BID ADDENDUM #2

Nanuet Union Free School District
103 Church Street
Nanuet, NY 10954

Nanuet Bond Projects Phase 5

Date: January 30, 2025

FIRST FLOOR OVERALL PLAN (A5)
1/16" = 1'-0"

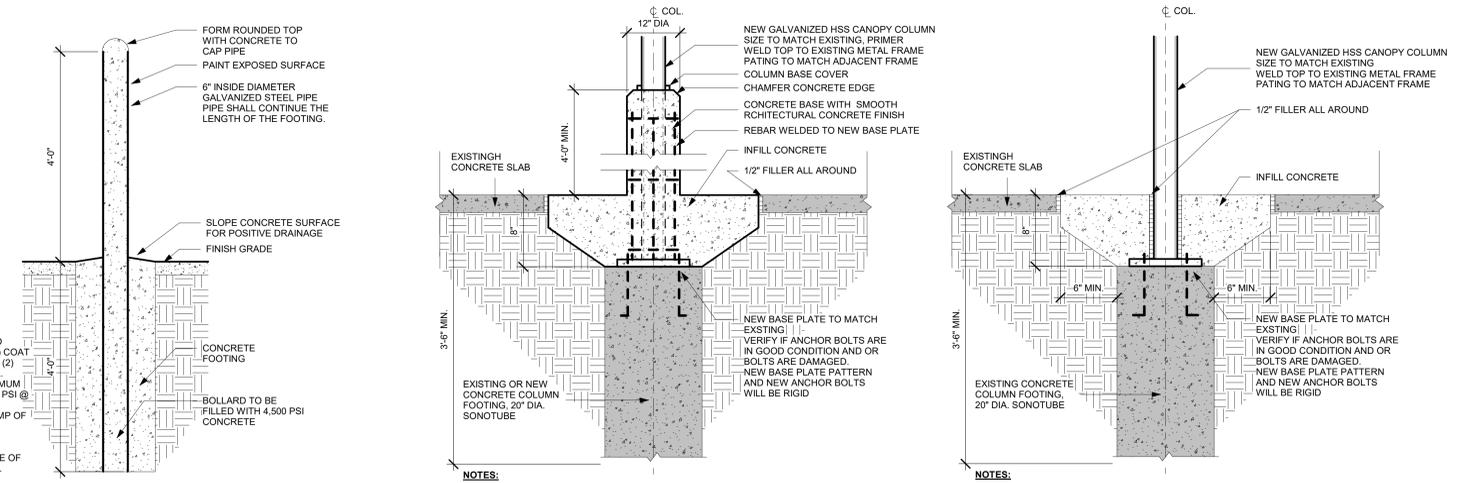
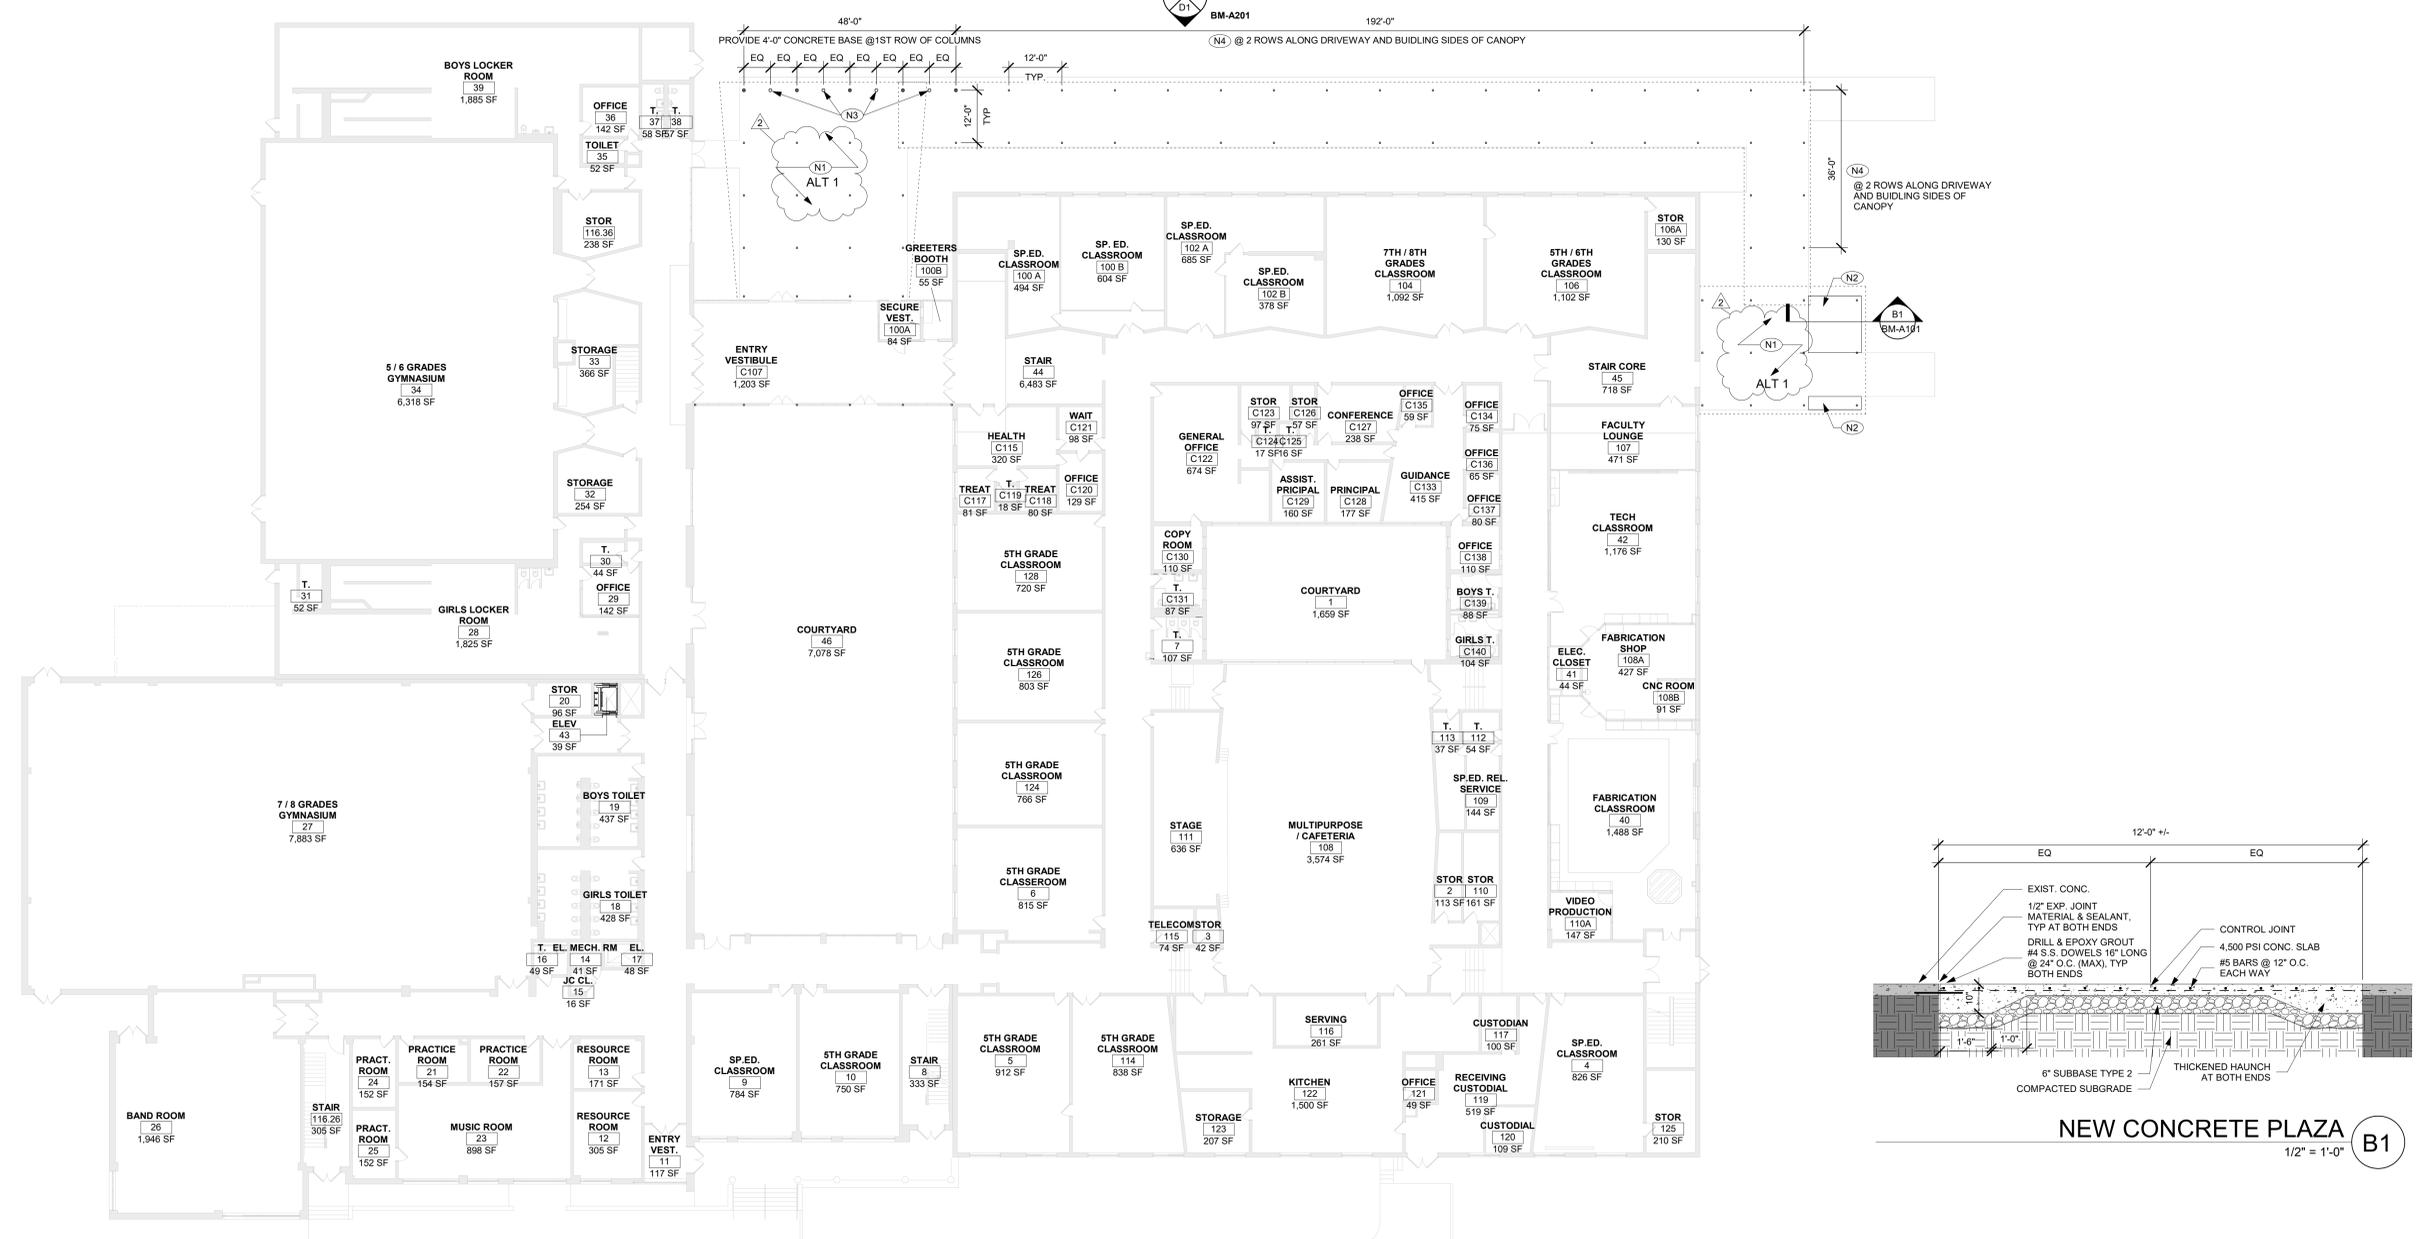
3. Sheet BM-A101: FIRST FLOOR OVERALL PLAN

SHEET NUMBER:
BM-A101.2

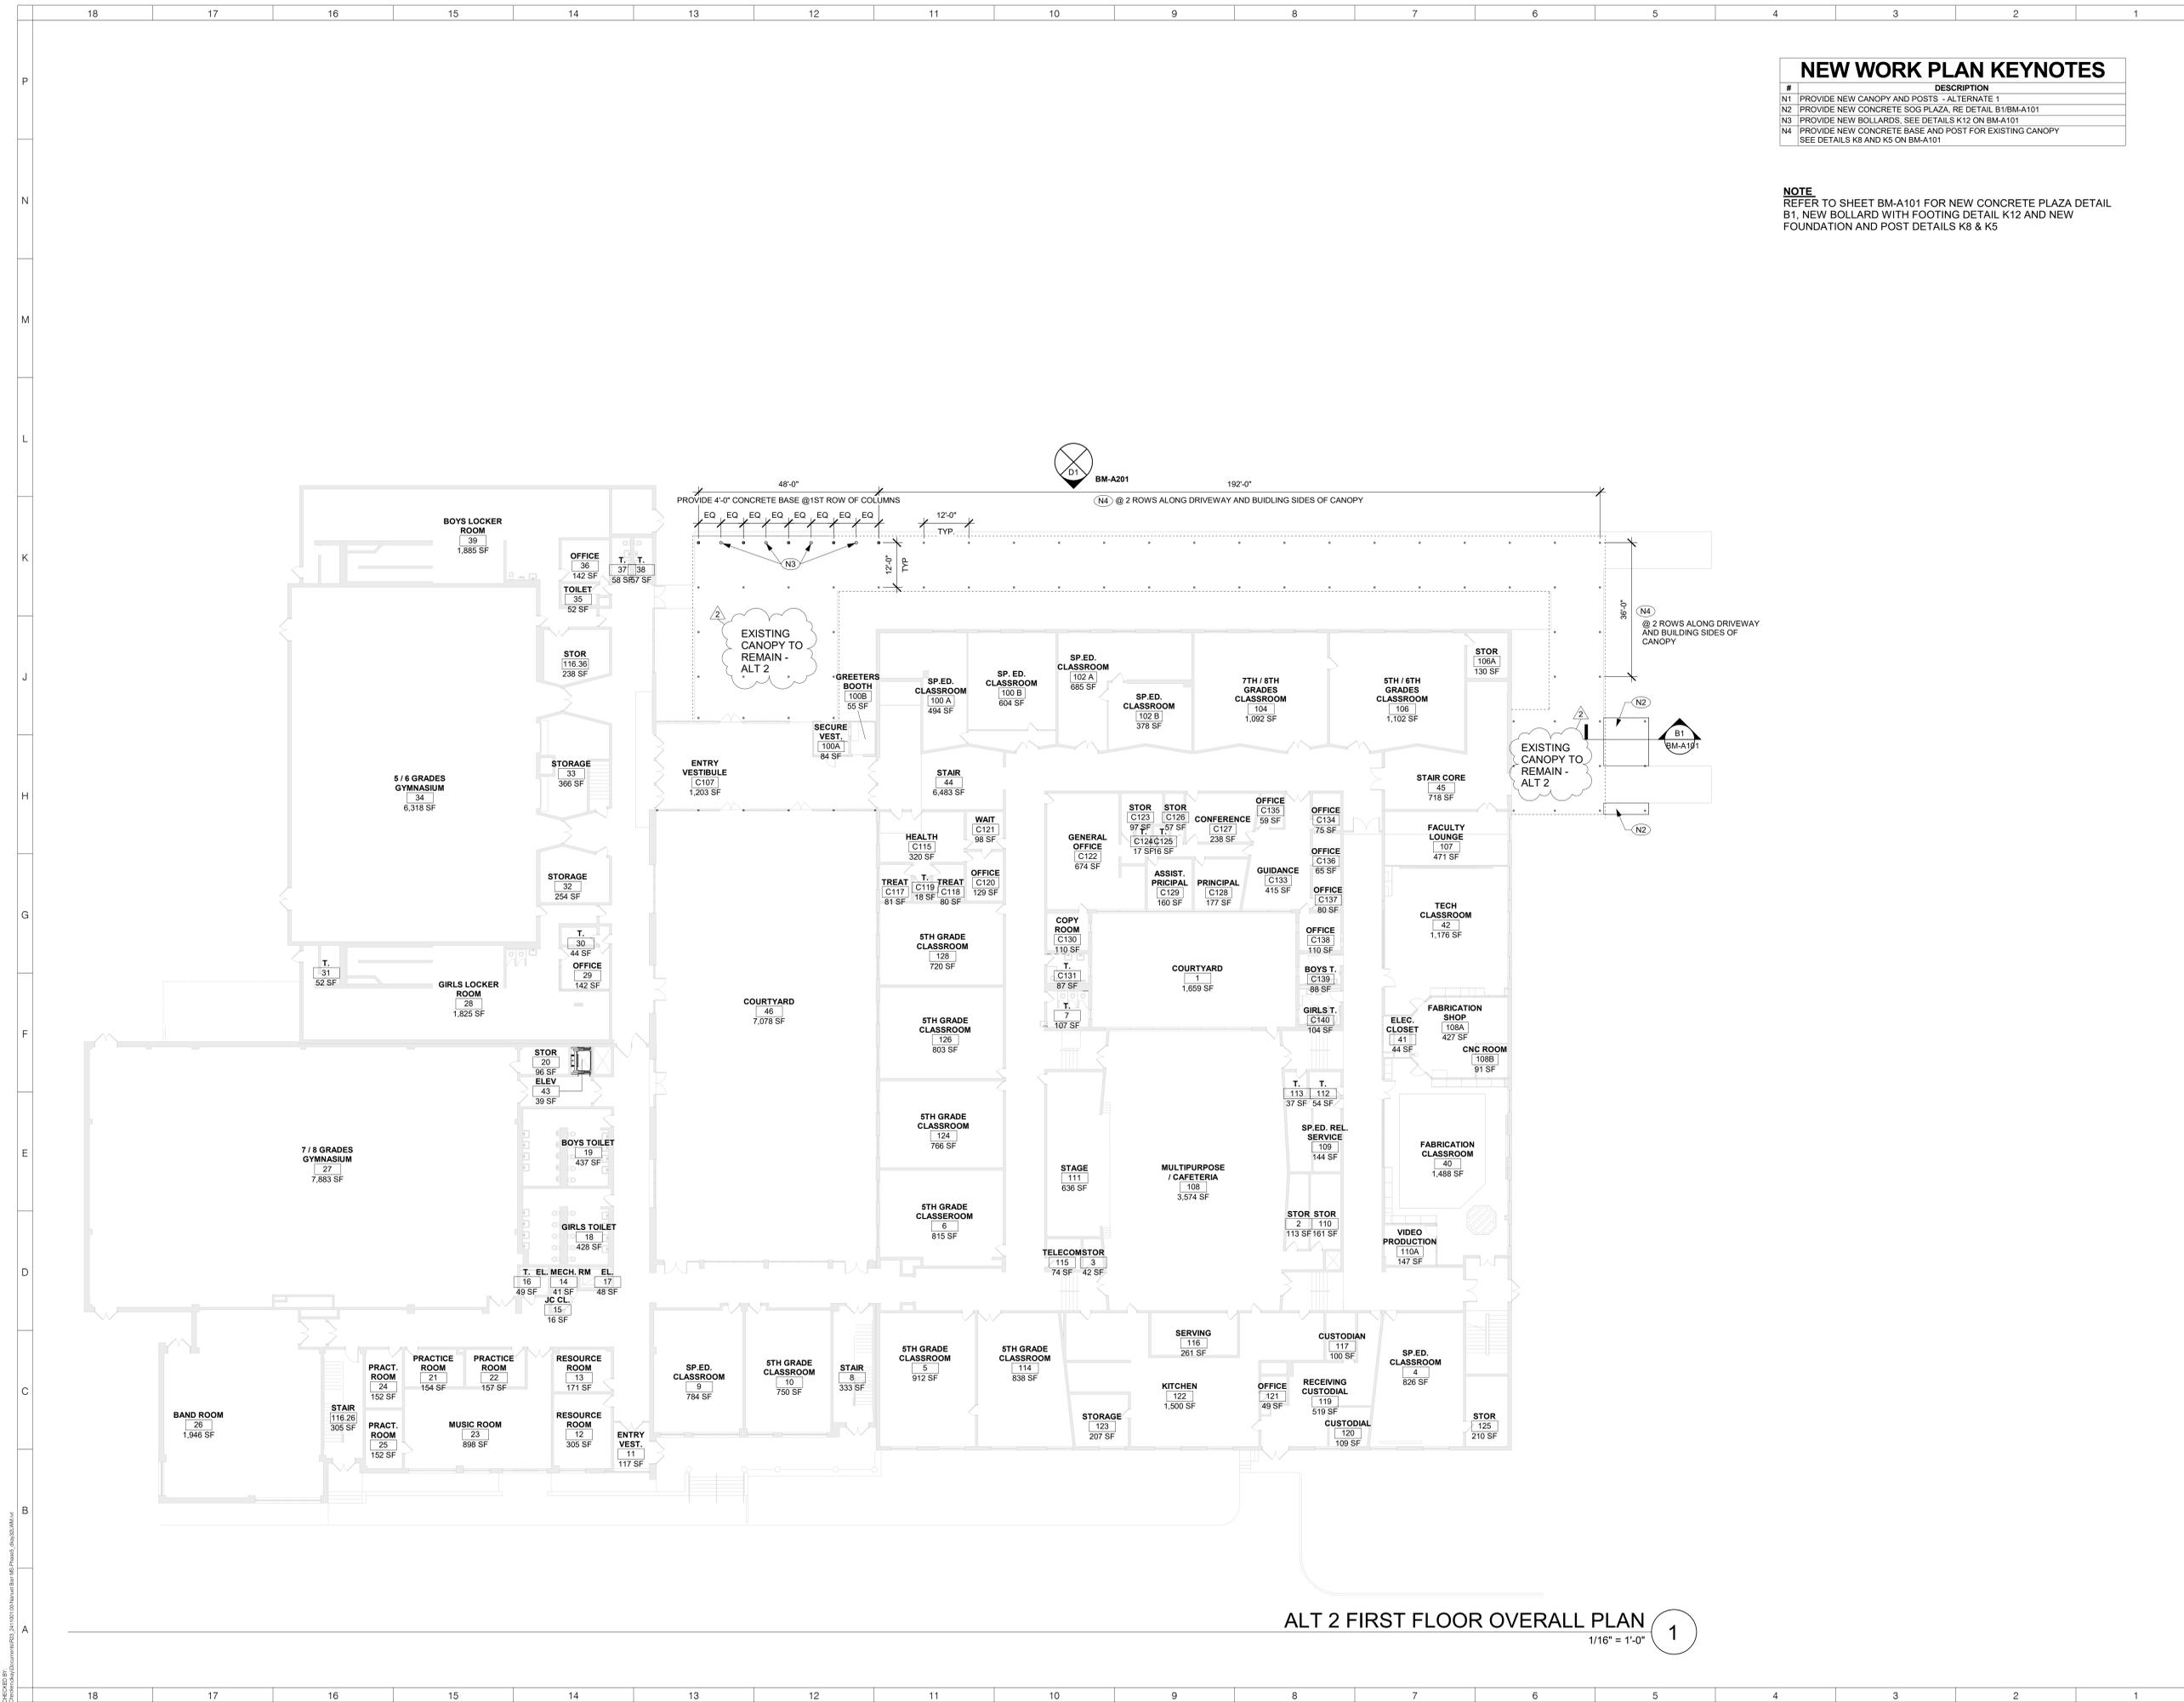
4. Sheet BM-A101.2: FIRST FLOOR OVERALL PLAN – ALTERNATE 2

A. Added sheet to reflect Alternate 2 notes for existing canopies at the main entrance and at the east side of the building to remain

SHEET NAME:
 FIRST FLOOR OVERALL
 RCP

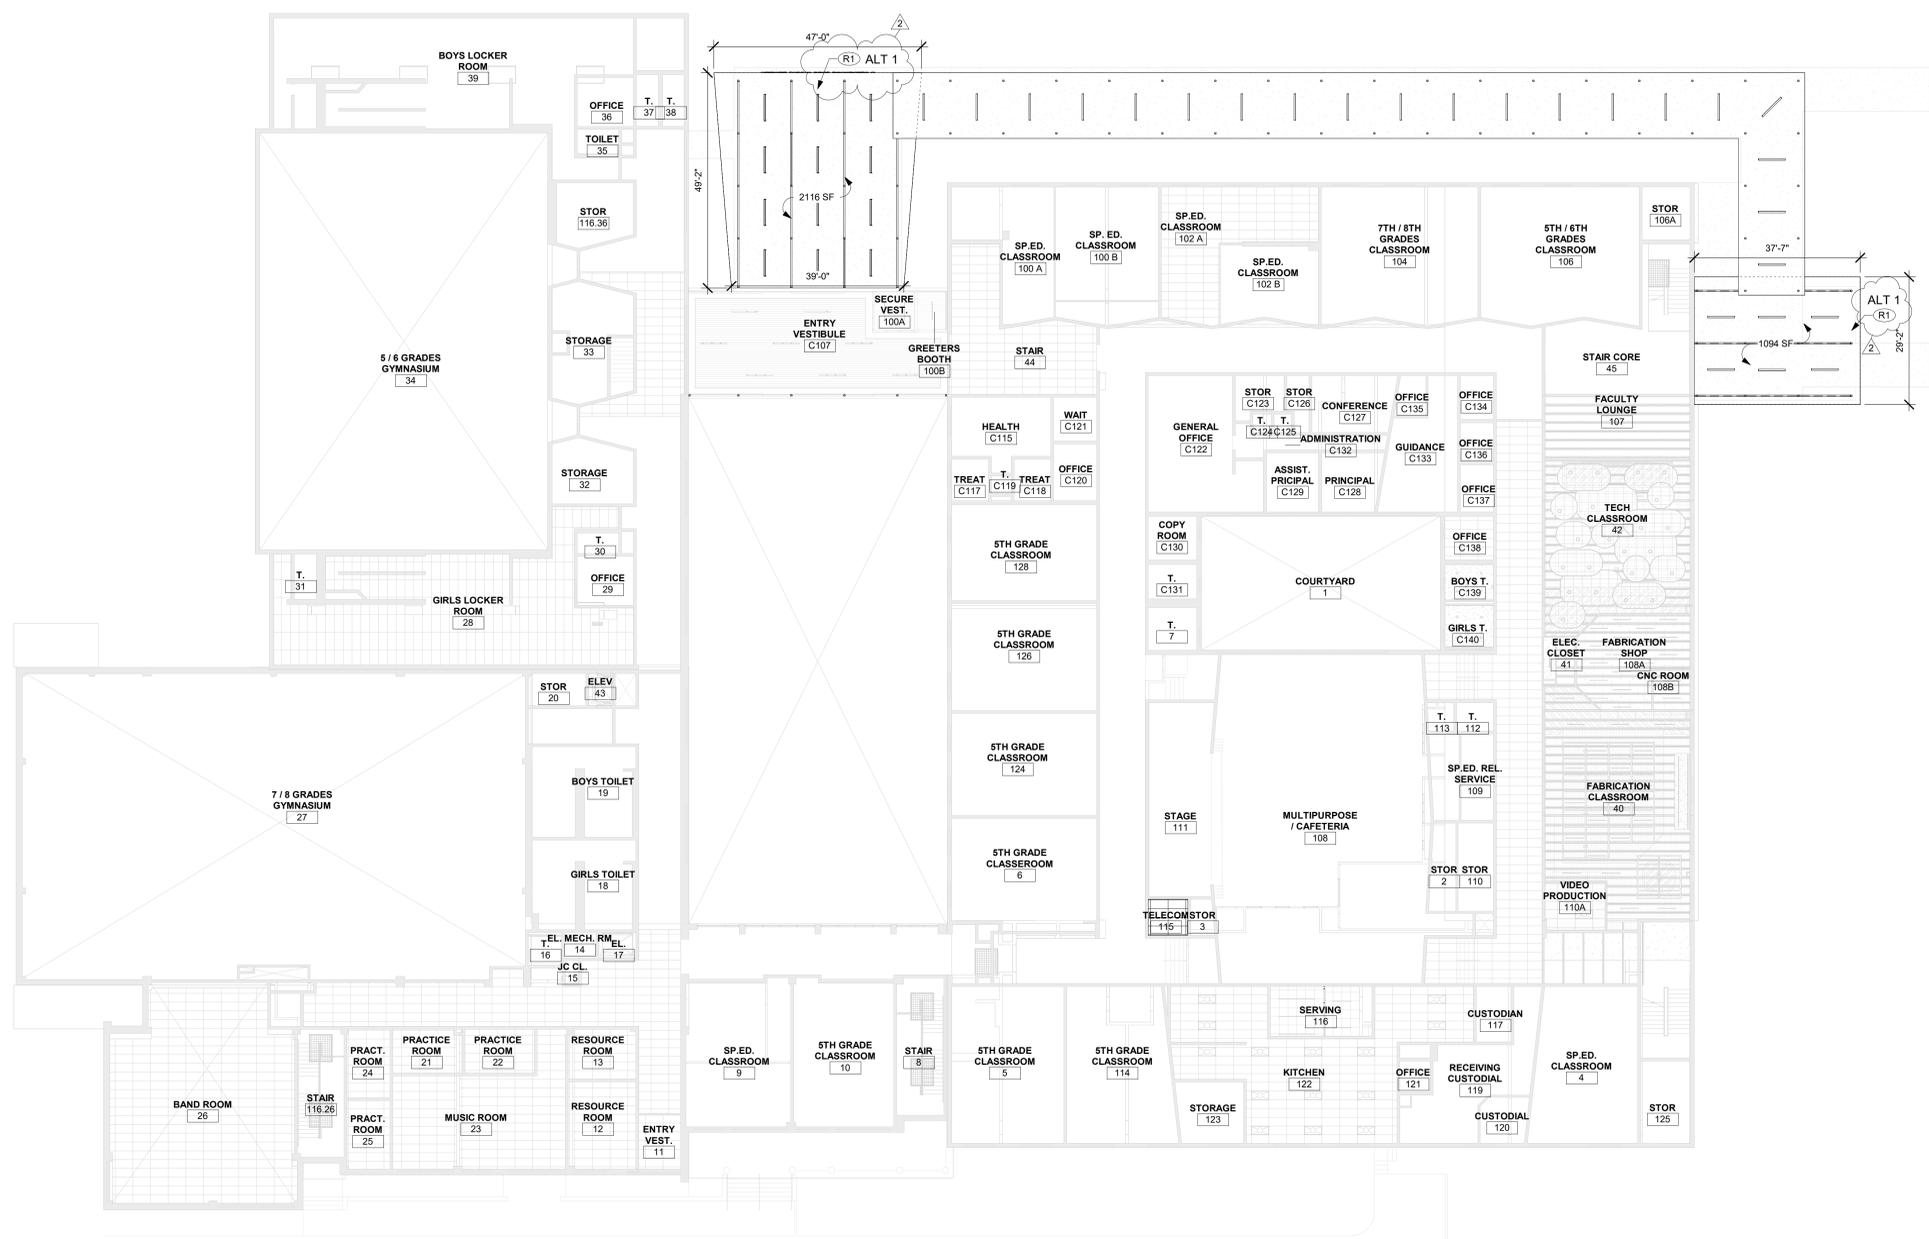
5. Sheet BM-A111: FIRST FLOOR OVERALL RCP
